02934 1 of 2 Columbia River Draft Environmental Impact Statement The Columbia River Crossing project welcomes your comments on the findings of the Draft Environmental Impact Statement or any other aspect of the project or process. Please fill out this form and use additional sheets of paper if necessary. Give this form to project staff or return to the project office. TELL US ABOUT YOURSELF SAME What is your home zip code? 97217 Work zip code? Do you: (check all that apply) How do you regularly travel in the project area: (check all that apply) Live in the project area? Commute through the project area? Bus? Bicycle? Work in the project area? 1 Walk Other Car or Truck ? Own a business in the project area? Other 1.5 LONNELTION FROM MARINE DR TO NES FREENAN ENT P-0101-001 RE FAVOR OF THE OPTION CONNELENCE HI OPAT VANCONER ·MI SEDBUTHE IVE D SEF A CONVECTOR MOM MARINE DRIVE CROSSING RUK KONG TH VANCOUVER WAY THAT FOOT RUNS ALONG THE DEVELOPED UCICO EGENTIALLY A DIRELT ROUTE. IVE TO THE RAMP TO MIKI GARTEN BINE ST OR GUGHTUN WEST.

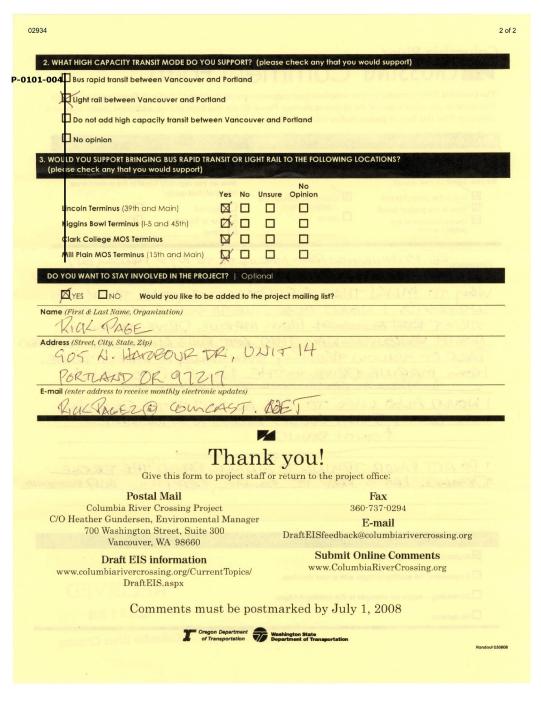
P-0101-002 WOULD ALSO LIVE TO SEE AN EXIT DITHE DEUTA PAGE MAX FROM 1-5 THAT COULD ALLESS NINTERSTATE. 1960TH BOUND

P-0101-008 DO NOT FAVOR TRYING TO GINGER BREAD "THE PRIDGE TRESIGN. LET'S KEEP IT SIMPLE, GRACEFUL, AND FUNCTIONAR

1-004 .Rep	place the existing bridges	
	plement the existing bridges with a new structure nothing—make no changes to the existing bridges	RECEIVED
	opinion	JUN 2 3 2008

The LPA includes a complete reconfiguration of the Marine Drive interchange, including a direct connection from Marine Drive to Martin Luther King Jr Blvd. For more information, please see FEIS Chapter 2 (Section 2.2).

I-5 southbound would have an exit to N Denver Avenue where motorists could access the Delta Park/Vanport Max station and Interstate Avenue southbound.

The CRC project design for interchanges, roadway elements, transit stations, and other facilities will be context-sensitive and reflect the unique character of the surrounding area. CRC formed a 14-member, bistate Urban Design Advisory Group (UDAG), made up of design professionals and neighborhood representatives. The goals of the UDAG include, achieving "design excellence that can be embraced by affected communities and users" and providing "a landmark bridge that is both inspired and inspiring and fully integrates the design and function of the structure with the urban design elements." Working closely with project designers, UDAG will provide input and guidance on integrating the new facilities with the surrounding community. The UDAG has repeatedly emphasized the preferrence for a streamlined bridge with ornamentation playing functional, not merely aesthetic, roles.

Preferences for specific alternatives or options, as expressed in comments received before and after the issuance of the DEIS, were shared with local sponsor agencies to inform decision making. Following the close of the 60-day DEIS public comment period in July 2008, the CRC project's six local sponsor agencies selected a replacement I-5 bridge with light rail to Clark College as the project's Locally Preferred Alternative (LPA). These sponsor agencies, which include the Portland City Council, Vancouver City Council, TriMet Board, C-TRAN Board, Metro Council, RTC Board, considered the DEIS analysis, public comment, and a recommendation from the CRC Task Force when voting on the LPA.
